# Final Environmental Impact Report NextEra Energy Transmission West's Proposed Suncrest Dynamic Reactive Power Support Project

Volume 3 – Comments and Responses to  
Comments on the Draft EIR

January 2018  
SCH # 2016011004

**Figure 1.** Site conditions at proposed SVC site on 22 December 2014.

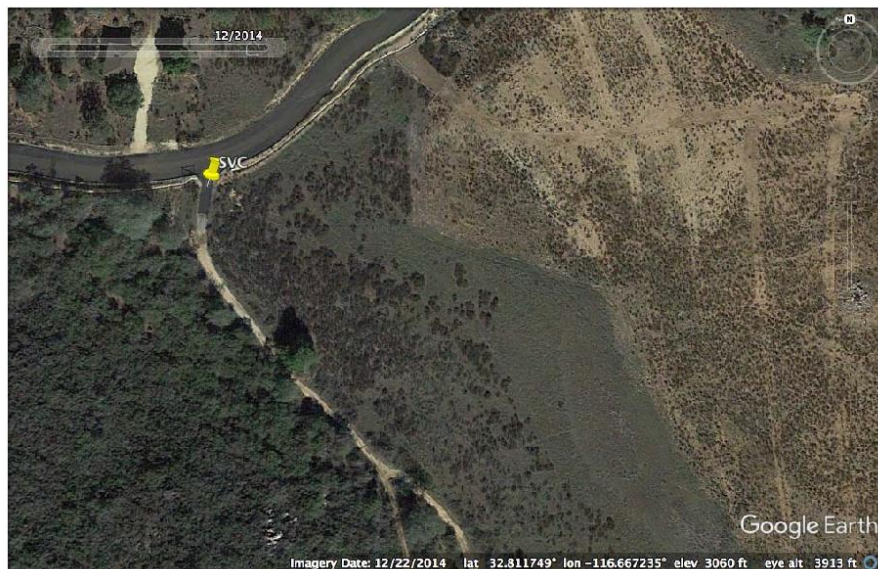
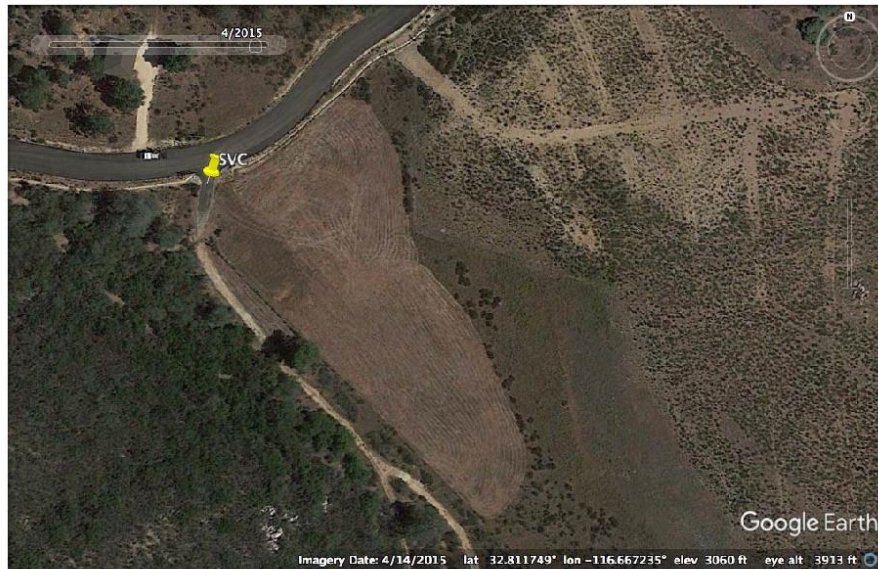
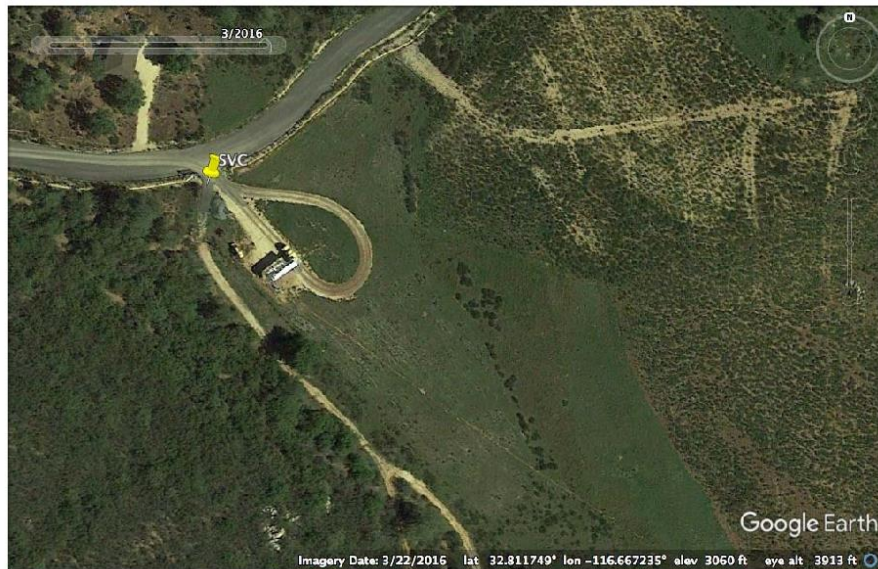
The property owner cleared the site sometime between December 22, 2014, and April 14, 2015 (Figures 1 and 2). The property owner then installed a dirt road and large water tank sometime between April 14, 2015, and March 22, 2016 (Figures 2 and 3). Although the Proponent’s Environmental Assessment (“PEA”) suggests the water tank was installed for SDG&E’s restoration efforts, that information appears inconsistent with the timing of SDG&E’s restoration program (which was deemed complete in March 2016).<sup>23</sup> As reported in the PEA, the tank will provide an on-site water source for the water needed during Project construction in the event that reclaimed water sources are unavailable.<sup>24</sup> Furthermore, although the PEA claims the “ruderal” portion of the Project site has been subject to repeated disturbance over the past two decades,<sup>25</sup> that claim is inconsistent with time-lapse imagery available through Google Earth. Nevertheless, the amount of land that was cleared and graded by the property owner far exceeds the amount of land that would be needed to install a water tank for SDG&E’s restoration efforts. Thus, existing evidence strongly supports the inference that grading and clearing were conducted in preparation for the proposed Project and not for some other purpose

(e.g., as part of the property owner's routine maintenance of the property). As a result, the environmental baseline for the "ruderal" portion of the Project site needs to be revised to reflect the conditions present when the property owner cleared the site.

**Figure 7-1  
Vegetation Types**

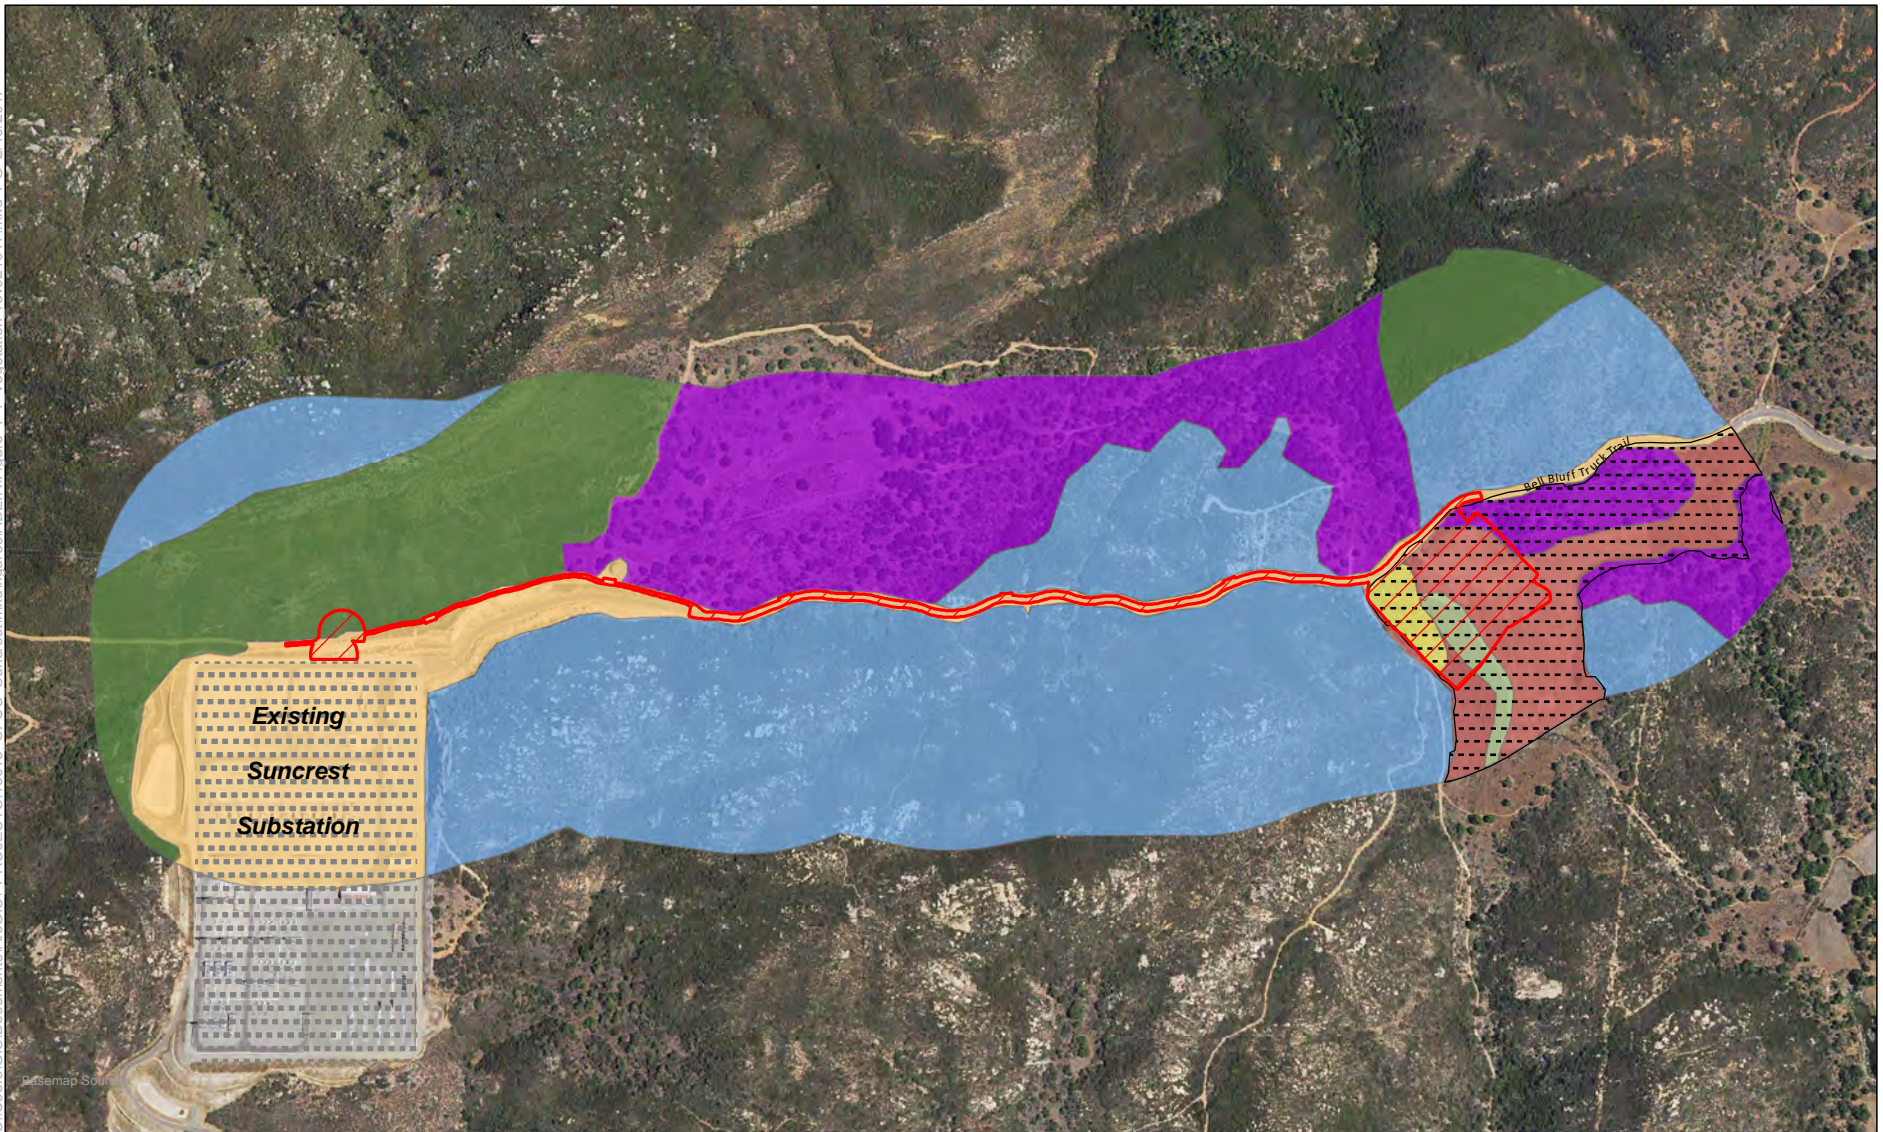
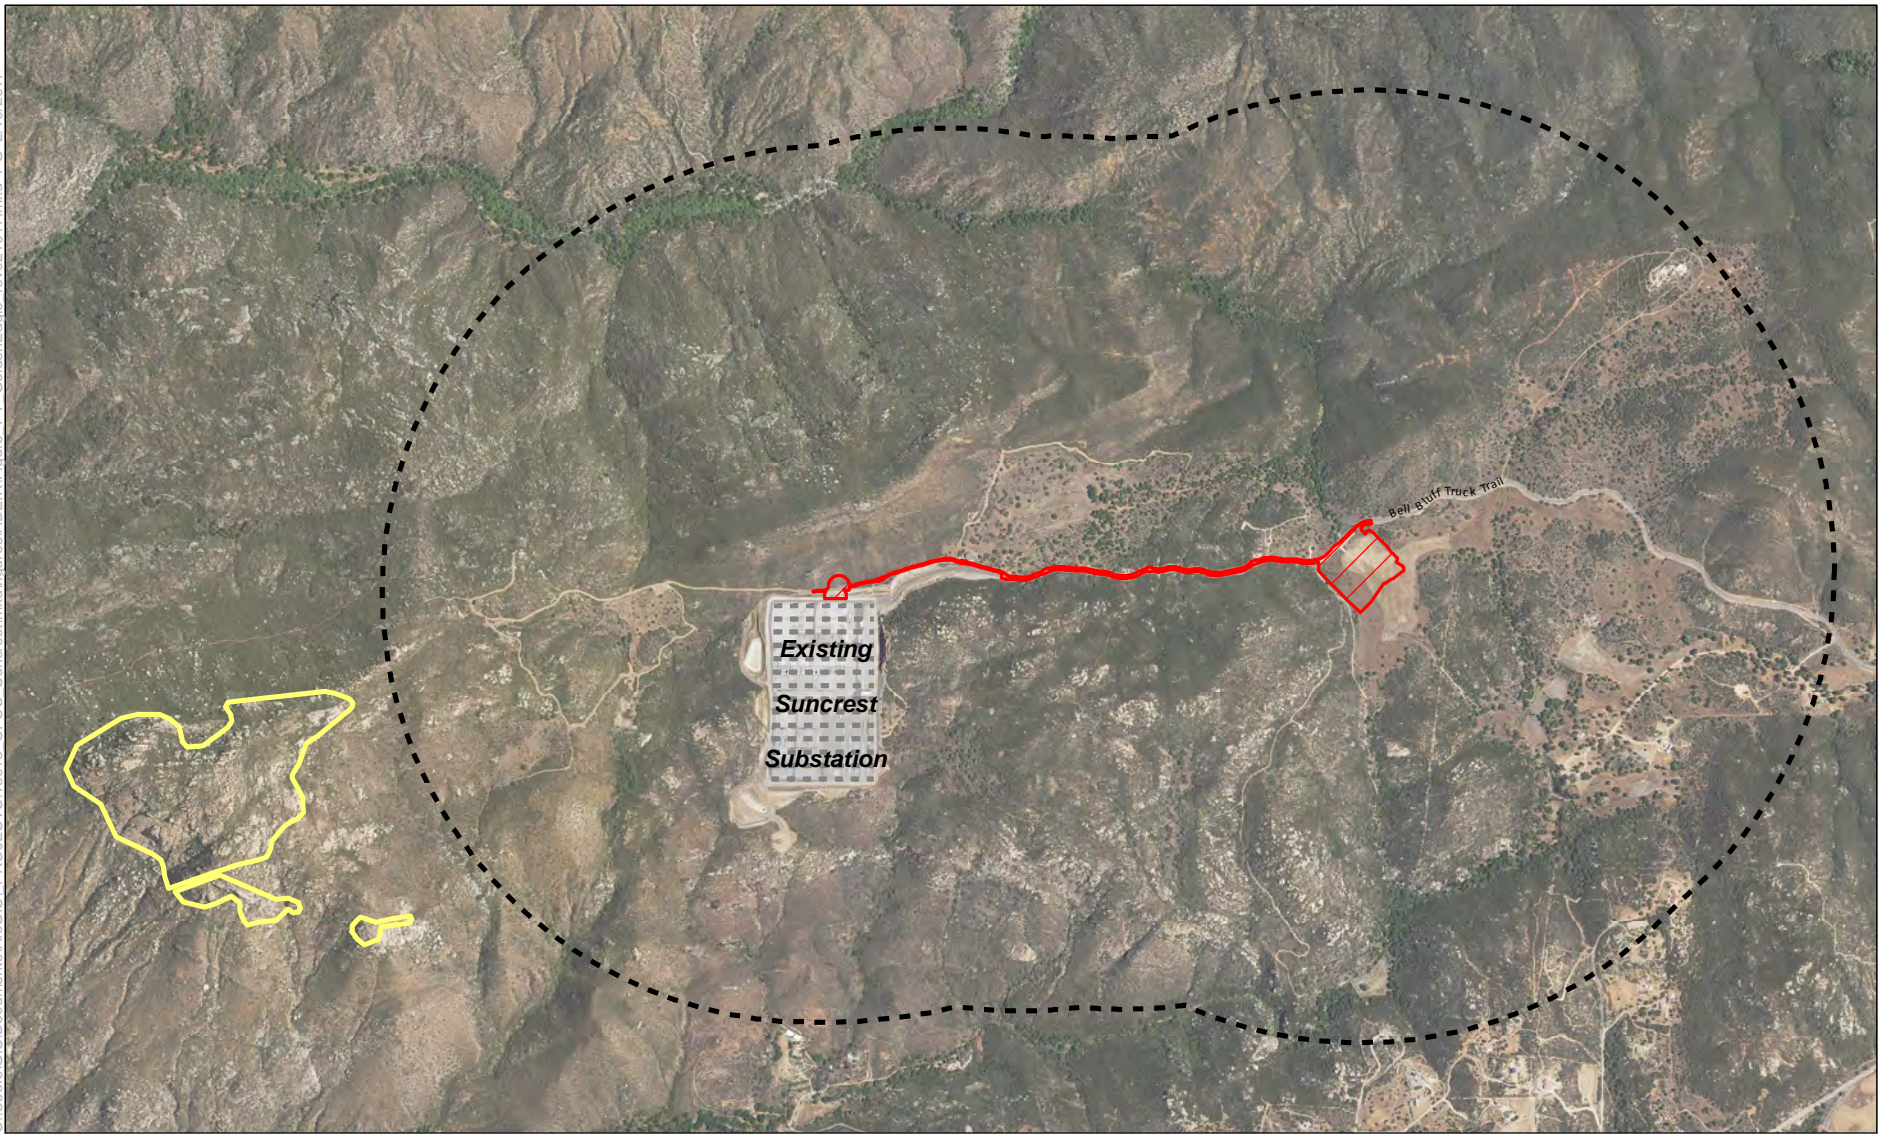
CHAPTER 7, BIOLOGICAL RESOURCES						
		Pages 7-7 and 7-37	Figures 7-1 and 7-7	Please update Figures 7-1: Vegetation Types and 7-7: Likely Golden Eagle Nesting Area to include the existing Suncrest Substation with cross-hatching, consistent with the other aerial figures in the DEIR.				
Page 7-14, Lines 20-21	Special-Status Species “Plants considered by the California Native Plant Society [CNPS] to be “rare, threatened, or endangered in California” (CNPS Rare Plant Ranks 1, 2, 3 and 4)”	The California Department of Fish and Wildlife (“CDFW”) administers the Native Plant Protection Act and generally regards as rare many plant species included on California Rare Plant Rank (CRPR) 1A, 1B, 2A, and 2B of the California Native Plant Society (“CNPS”) Inventory of Rare and Endangered Vascular Plants of California. In addition, sometimes CRPR 3 and 4 plants are considered if the population has local significance in the area and is impacted by the project.  As a result, please revise the DEIR text to read:  “Plants considered by the California Native Plant Society [CNPS] to be “rare, threatened, or endangered in California” (CNPS Rare Plant Ranks 1, 2, <u>and sometimes</u> 3 and 4)”

Figure 7-1: "Vegetation Types" and Figure 7-7: "Likely Golden Eagle Nesting Area" have been revised to include cross-hatching. Please refer to Chapter 4, *Revisions to the DEIR* for the revised figures.

Figure 7-1: "Vegetation Types" (page 7-7) and Figure 7-7: "Likely Golden Eagle Nesting Area" (page 7-37) have been revised to include cross-hatching over the existing Suncrest Substation. The revised figures are presented on the pages below.
